**City of Portland, Maine – Building or Use Permit Application** 389 Congress Street, 04101, Tel: (207) 874-8703, FAX: 874-8716

# BUILDING PERMIT REPORT

REASON FOR PERMIT: Temp. wheel Chair Ramp

# TEMPORARILY RAMP APPLICATION

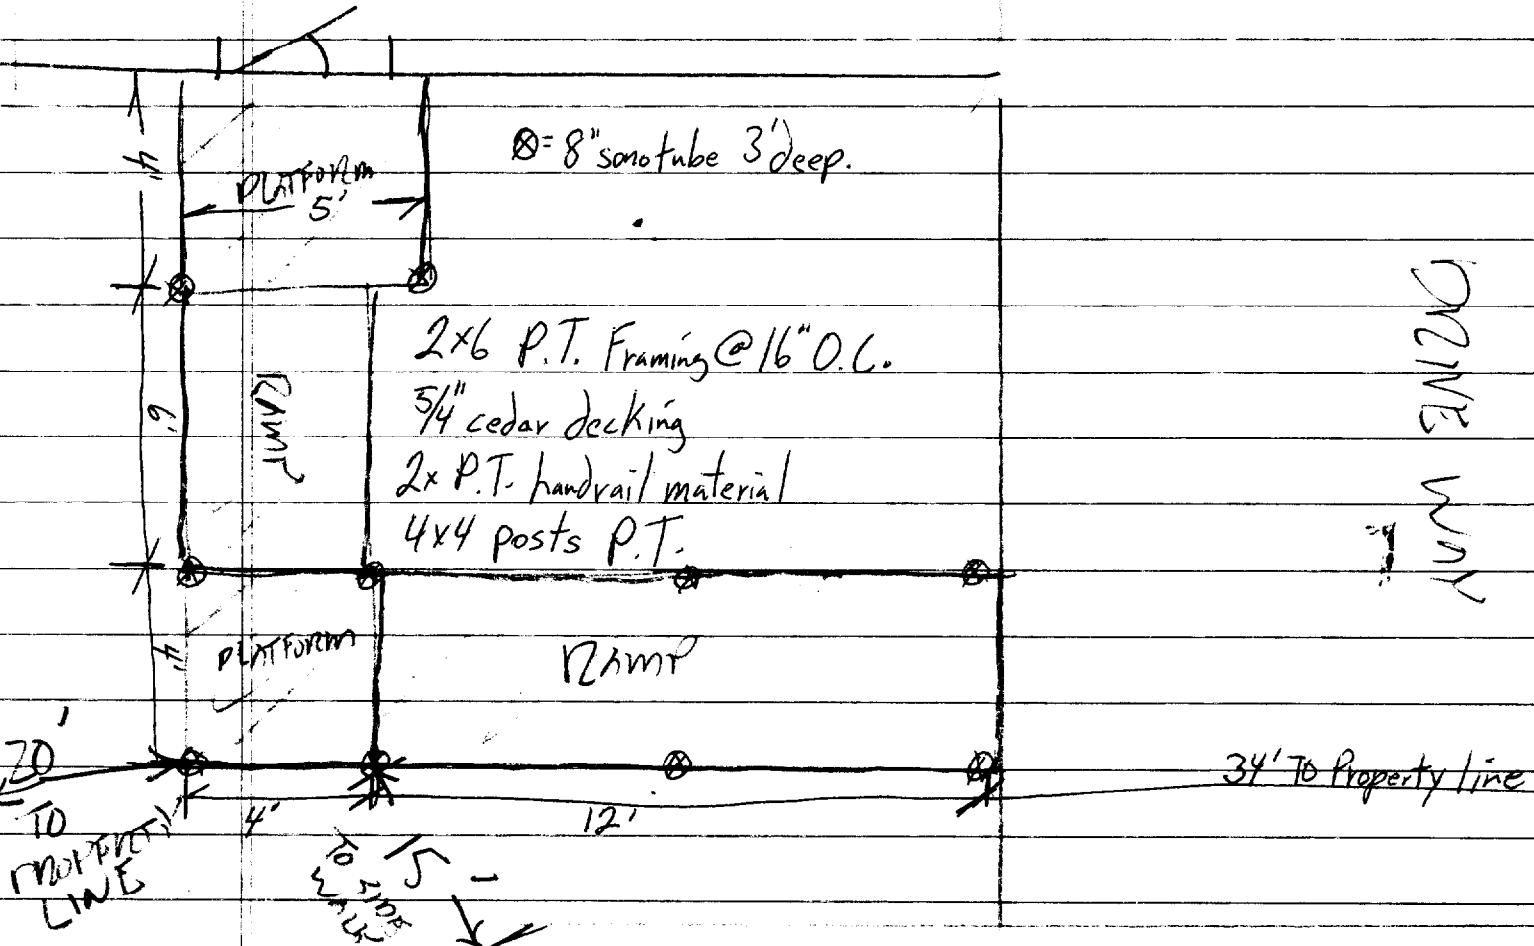
\*37. Please read and implement attached requirements for ramps (Sec. 1016.0).

38) This permit is valid for temporary use only and shall be removed within one year from the date of construction. If the ramp is required for a longer period of time, a handicap variance from the zoning Board of Appeals shall be required, checked without a fee at that time for the appropriate paperwork.
